ACCESS REPORT

PROJECT: **Hickson Road Upgrade, Stage 3 & 4**
PROJECT NO: **GDL230396 and GDL240556**
PREPARED FOR: **Lendlease and Infrastructure NSW**
REVISION: **C**
DATE: **31.10.2025**

The items in the table below have been noted as items of relevance at this stage of the review. The items that have been considered non-compliant require further review against the detailed design. refer to Appendix B for marked-up comments on drawings.

Figure 4.3.1 – Plan of new kerb ramps across Waterman’s Quay and Barton Street, shown highlighted in blue

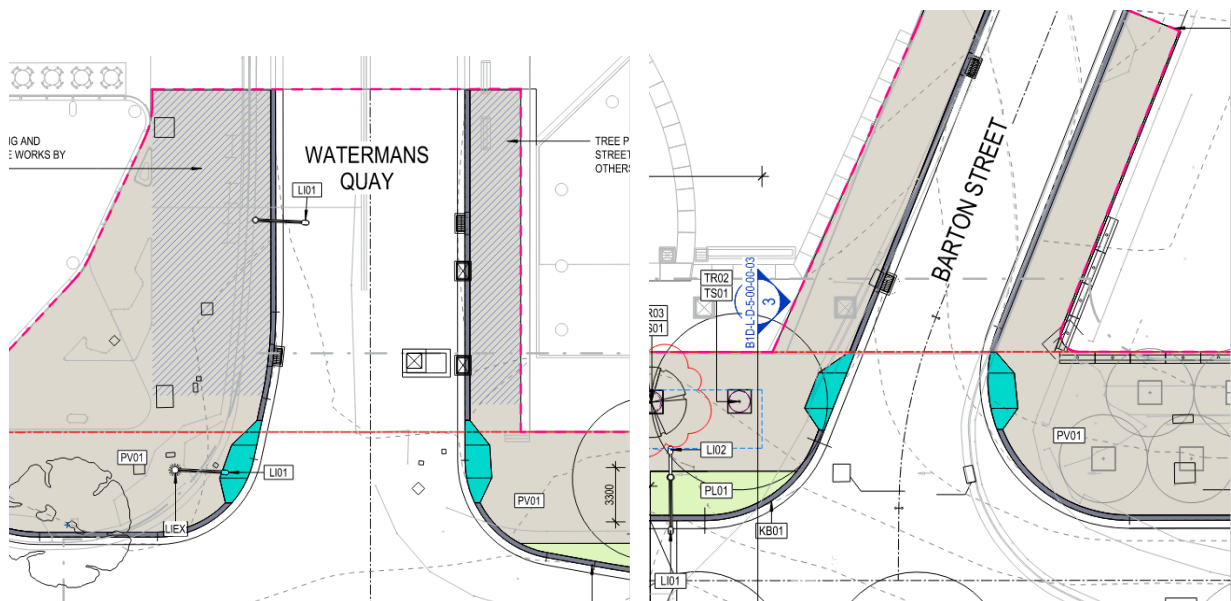
- The top and base of the kerb ramps are not perpendicular to the path of travel to cross the road. Re-orienting the kerb ramp design to provide 90 degrees at top and base in accordance with AS1428.1:2009 Figure 23b is recommended. *Note: It has been advised by the design team that the proposed kerb ramp design has been maintained to meet City of Sydney design requirements.*
- The angle of splayed portions of the kerb ramps at pedestrian crossings are to be 45 degrees – too shallow as it is currently drawn.

Figure 4.4.1 – Plan of new raised Hickson Road double pedestrian crossings near Barton Street

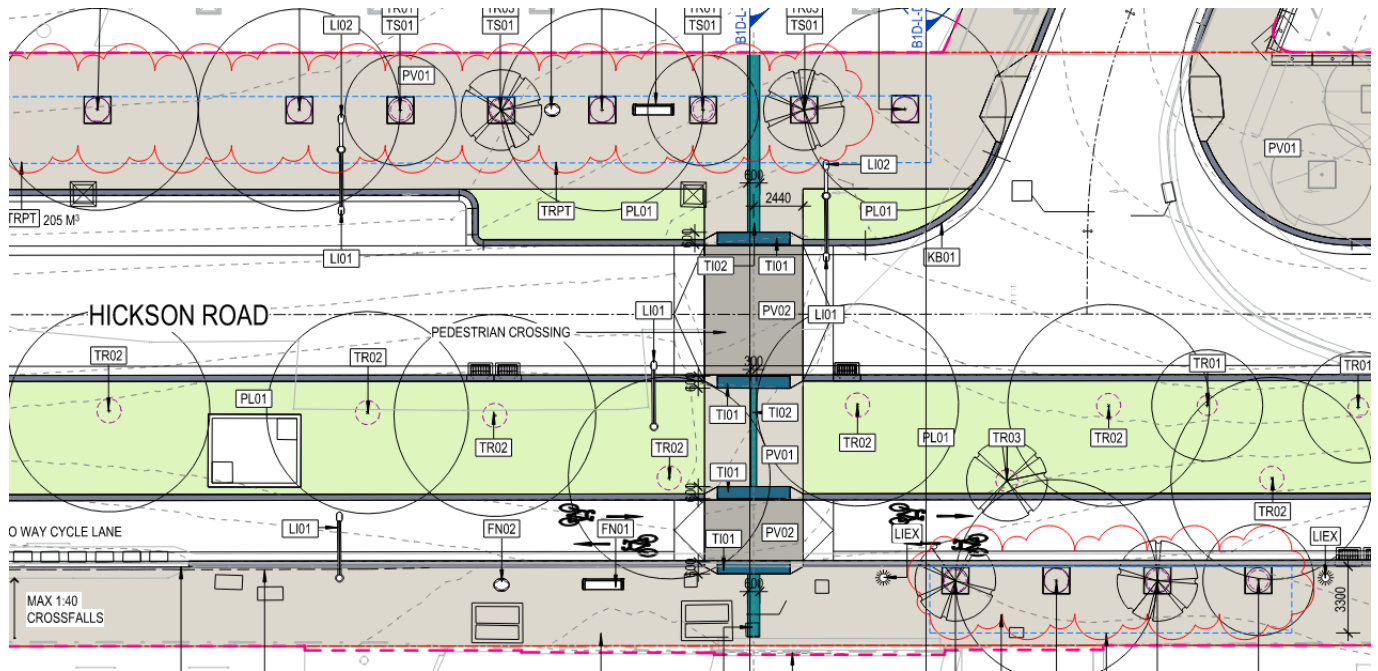
The pedestrian path of travel across the crossings requires hazards to be traversed. The minimal length/height kerb ramps may be difficult to detect even if designed to 1:8-1:8.5 gradient. Provision of 600mm depth warning TGSIs on the kerb ramps on either side of either crossing for compliance with AS1428.4.1 also been documented.

The designated crossings are located more than 3000mm distance from the building /property line. Provision of directional tactile ground surface indicators to connect to the kerb ramps at the crossing/road entry and between the consecutive crossings to assist location/detection by a person with vision impairment for compliance with AS1428.4.1 has been documented. Provision of 600mm depth directional TGSIs to the kerb ramps from the building/property line has been documented on the western side and is to fully extend to the building/property line has been on the eastern side of Hickson Road.

Figure 4.7.1 – Plan of potential new northbound taxi zone on Hickson Road, indicated by signage.

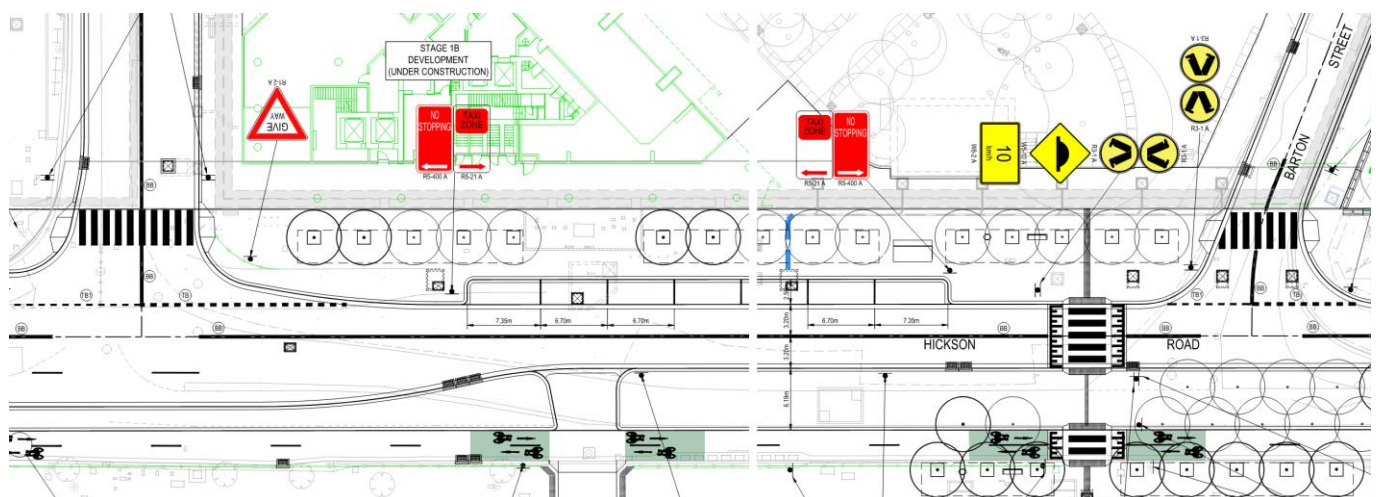
- The current dimensions of the seven (7) taxi zone vehicular spaces (6700mm Lx 2500mm W) are less than that required for accessible passenger loading zone. Provide at least one (1) vehicle space allocation with 7800mm L x 3200mm W, at the rear of the taxi rank.
- There is no kerb ramp proposed for step free access at taxi rank between roadway and footpath. Provide AS1428.1:2009 compliant kerb ramp at the rear of the accessible passenger loading zone.
- Consider designating the accessible passenger loading zone with appropriate line marking and signage in accordance with relevant Australian Standard AS2890.5 (and/or off-street AS2890.6).

DRAWING NO.
B1D-L-D-2-00-00-02

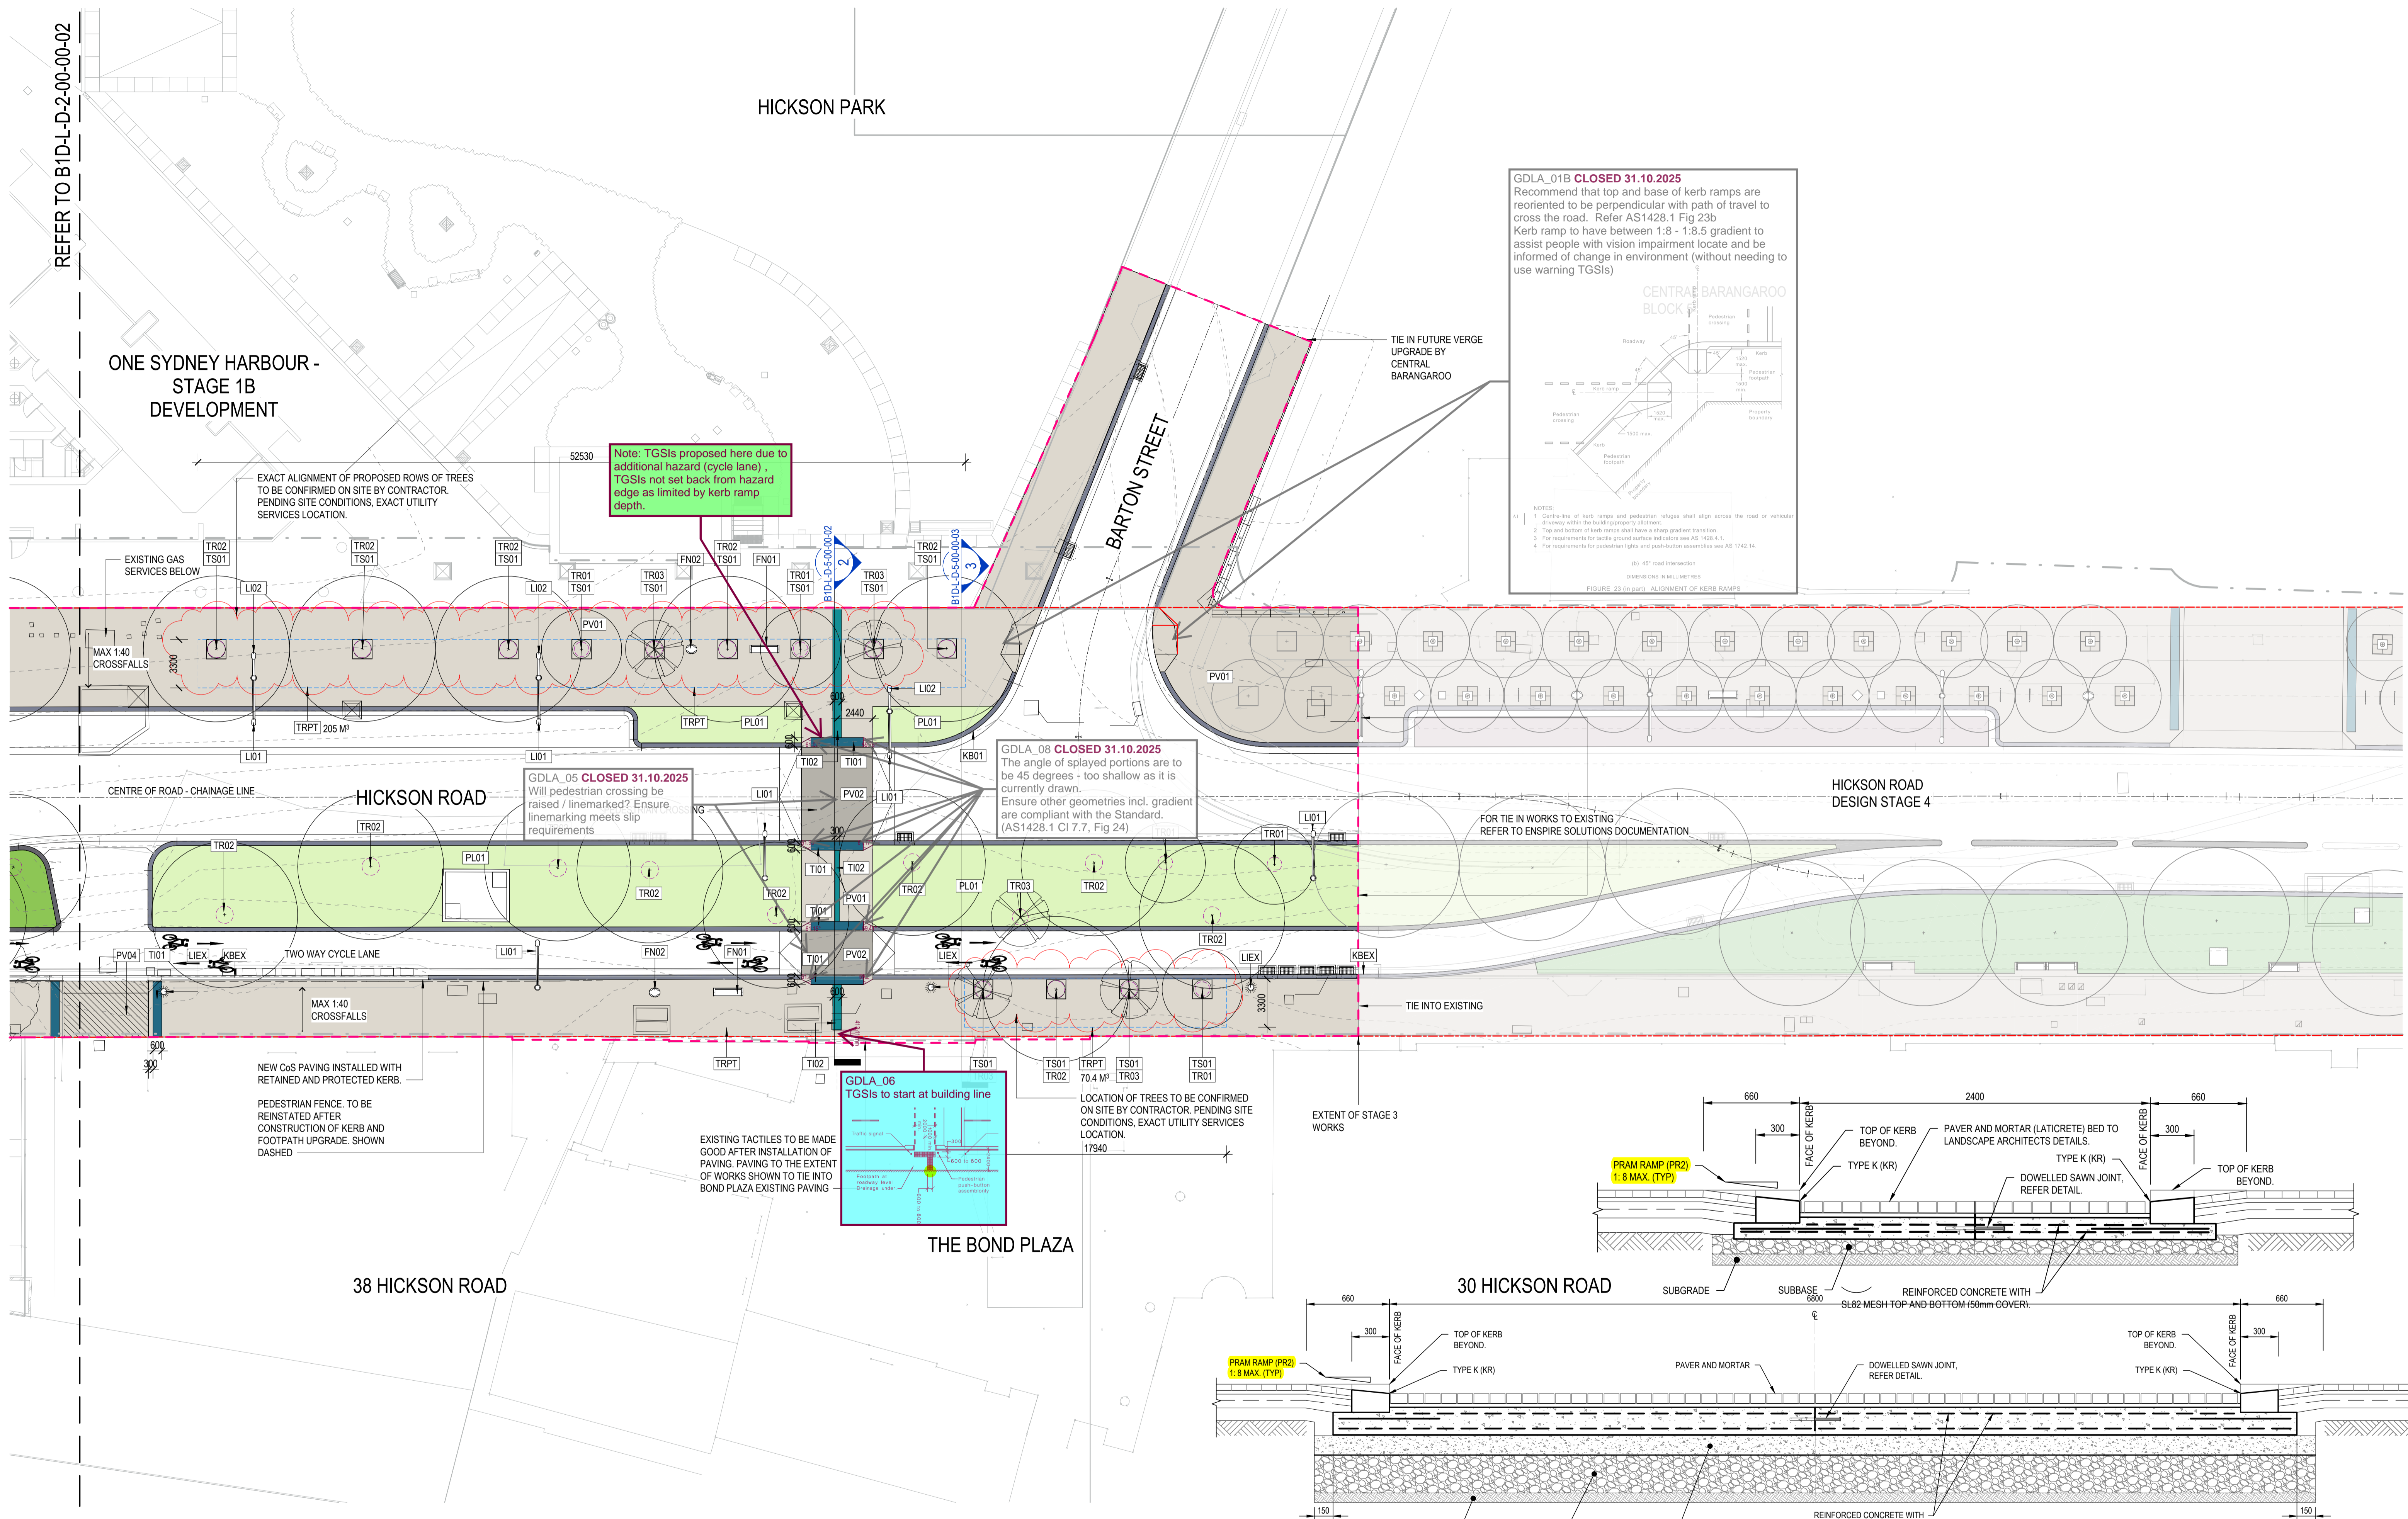
GDLA_01A CLOSED 31.10.2025
 Recommend that top and base of kerb ramps are reoriented to be perpendicular with path of travel to cross the road. Refer AS1428.1 Fig 23b
 Kerb ramp to have between 1:8 - 1:8.5 gradient to assist people with vision impairment locate and be informed of change in environment (without needing to use warning TGSIs)
